STAFF REPORT

Design & Development Manual Update

June 14, 2022 Town Council Meeting

BICYCLE PARKING

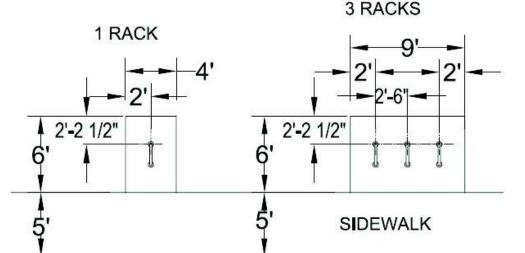
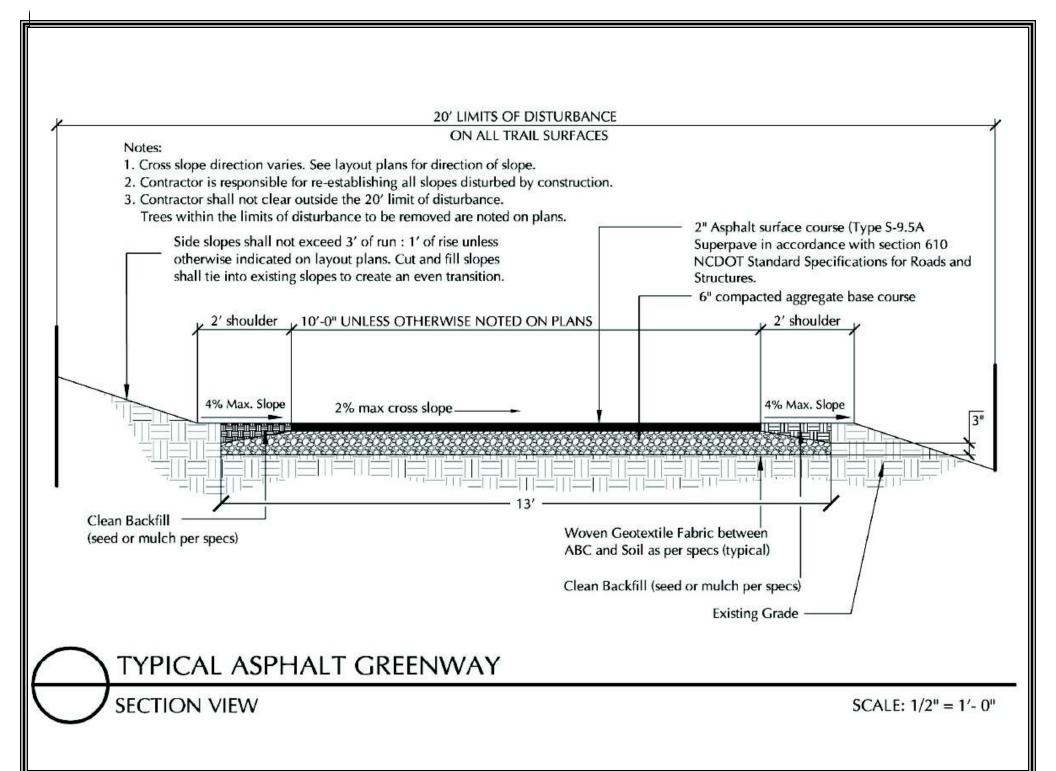
In order to avoid confusion, Planning Staff recommends removing the following details from the Design and Development Manual:

Detail Name	Specification Number:
Bicycle Parking	300.20
Typical Asphalt Greenway	900.01
Typical Keyed Concrete Path	900.01
Safety Railing	200.03 & 200.05
Bollard and Pavement Markings	900.06
